**REMARKS**

Serial No. 10/647,468  
Docket No. 2002-249352US

**AMENDMENTS TO THE DRAWINGS**

**FIG. 1**

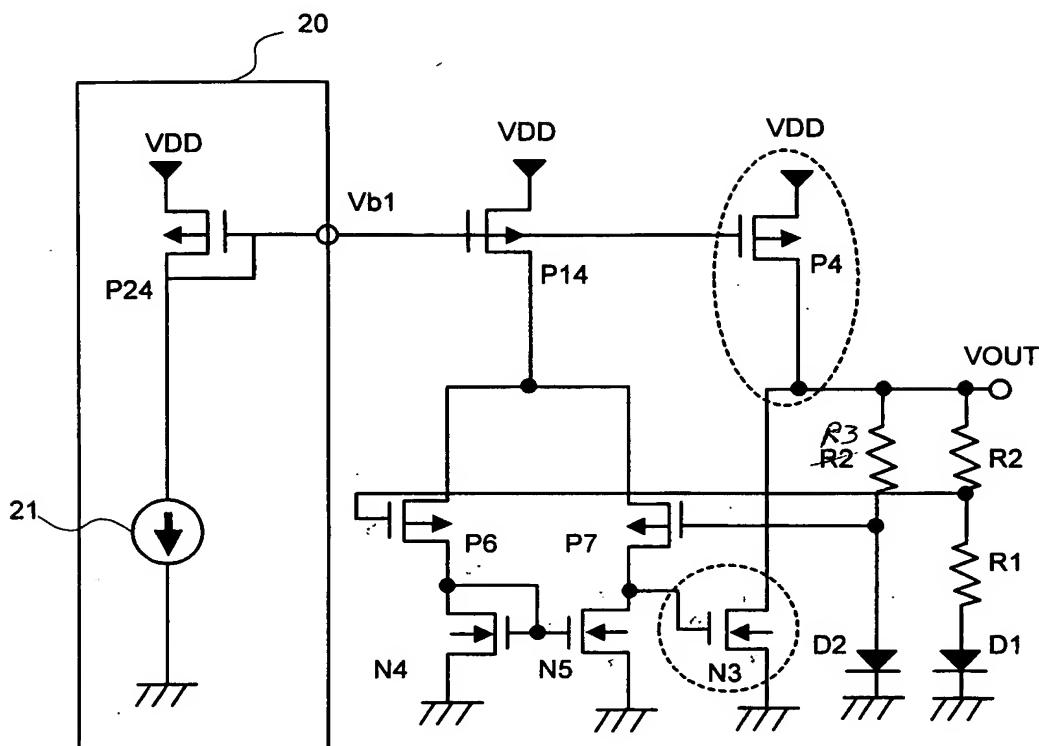
In Figure 1, the left-most reference character R2 is changed to R3.

**FIG. 2**

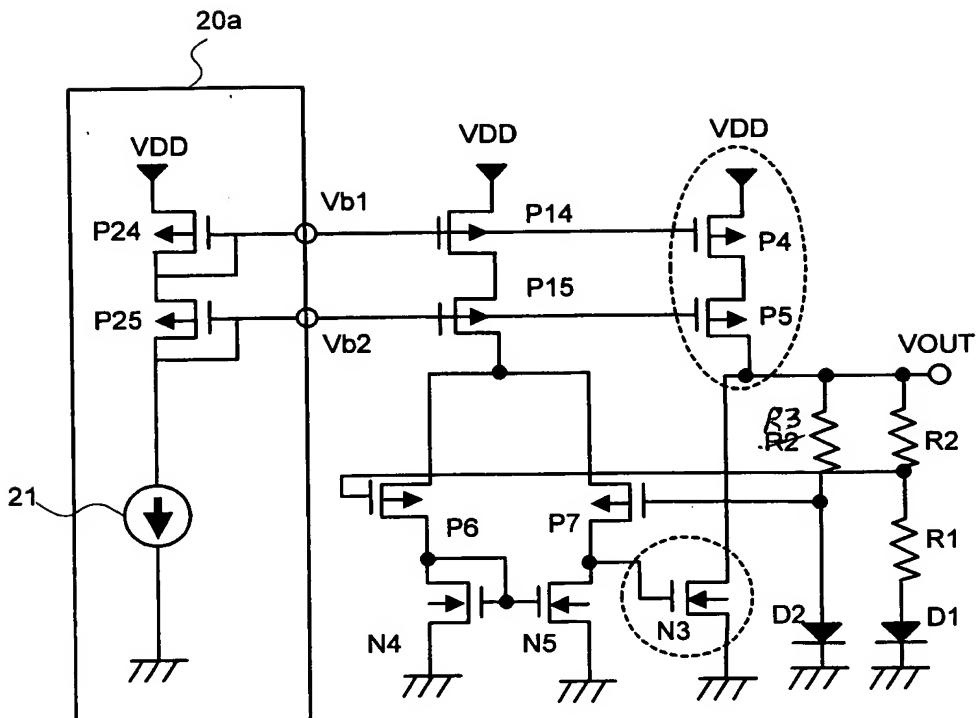
In Figure 2, the left-most reference character R2 is changed to R3.

**FIG. 8**  
**PRIOR ART**

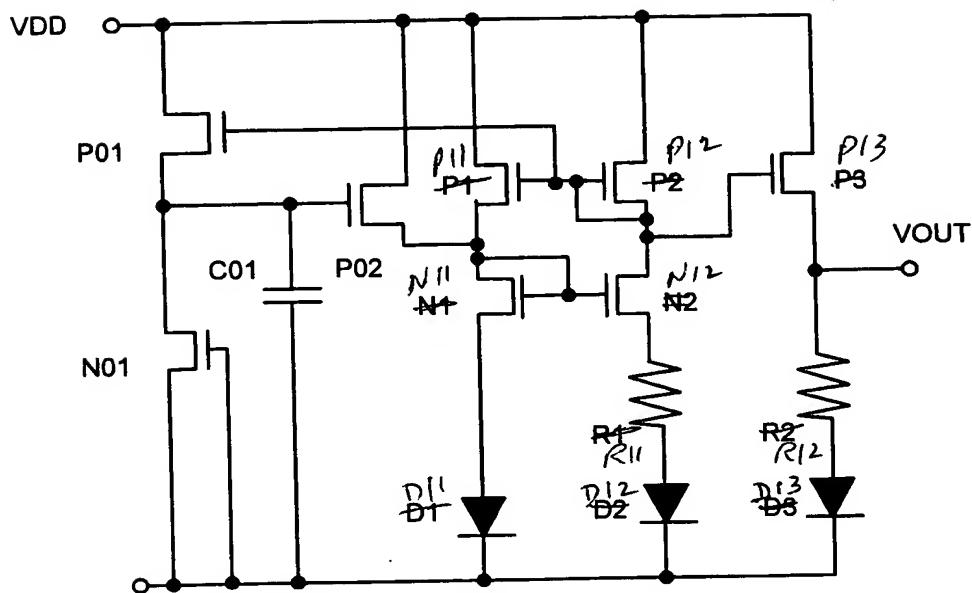
In Figure 8, reference character P1 is changed to P11, reference character P2 is changed to P12, reference character P3 is changed to P13, reference character N1 is changed to N11, reference character N2 is changed to N12, reference character R1 is changed to R11, reference character R2 is changed to R12, reference character D1 is changed to D11, reference character D2 is changed to D12, and reference character D3 is changed to D13.

**FIG. 10  
PRIOR ART**

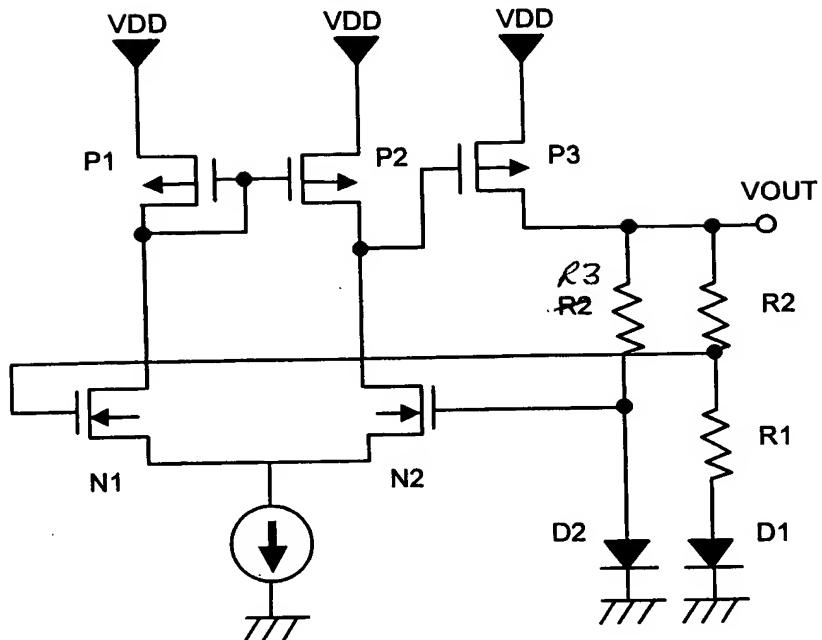
In Figure 10, the left-most reference character R2 is changed to R3.
